REQUEST Current Zoning: R-3 (single family residential), R-17MF (multi-family

Proposed Zoning: MUDD-O (mixed use development district, optional)

LOCATION Approximately 7.12 acres located at the northwest intersection of

SUMMARY OF PETITION

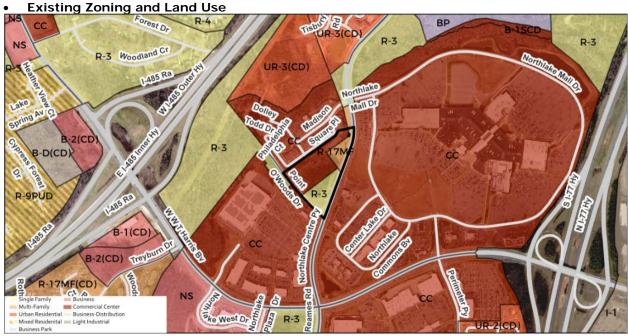
- 2. Limit the building height of proposed buildings to five stories per the adopted plan. Additional height is appropriate based on additional pedestrian design commitments as indicated in the adopted plan.
- 3. Provide operable entrance (or corner entrance) on Building C elevation facing Dolley Todd Drive extension. Addressed
- 4. Provide operable entrance on one of the frontage elevations of Building A and a direct connection to the public sidewalk. Addressed
- 5. Confirm if Building B is intended to be one building or two. Architectural standards have been provided on the plan. Petitioner response: We would like to have the option to build either a

- single building or two buildings dependent on the tenant demands. The total floor area is unchanged either way.
- 6. Provide multiple pedestrian connections for Building B (both buildings shown). Addressed
- 7. Amend Architectural Standards Note B to state: "...60% of the total exterior street facing elevations..." Addressed
- 8. Provide pedestrian pathways throughout the site/parking areas. Provide an integrated and organized sidewalk system to accommodate ample room for people to circulate, have outdoor dining, and to congregate. Provide ample room for furnishings such as lighting, receptacles, furniture, artwork, and trees. Addressed
- 9. Ensure dumpster(s) and service areas are away from surrounding residential uses and pedestrian areas. Petitioner response: Dumpsters will be screened on all four sides wherever located.
